Reference No. 21490001_7407-001-LR-RevA_DRAFT

Queenstown Lakes District Council
Level 1
74 Shotover Street
Queenstown 9348

REVIEW OF NATURAL HAZARD ASSESSMENTS FOR PROPOSED CONEBURN INDUSTRIAL AREA PLAN CHANGE

Figure 4: Debris flow/flood diagram indicating effect of slope on flow type. Red zone is likely to be consistent with Coneburn development conditions. After BGC (2020)³.

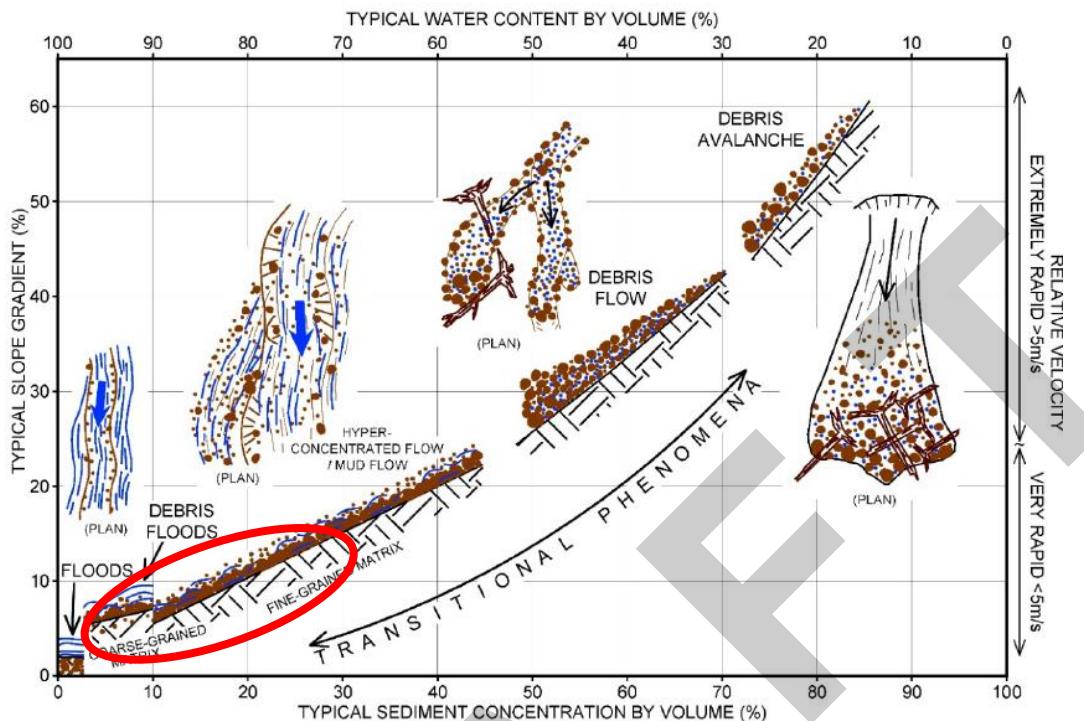
- It is difficult to represent the many uncertain variables in a debris flow/flood event scenario (water flow, debris volume, type, speed debris enters the water flow, percentage of debris etc). Geosolve's conclusions regarding the potential for debris flood (not debris flow) are consistent with empirical studies, including a separate source shown in Figure 4.
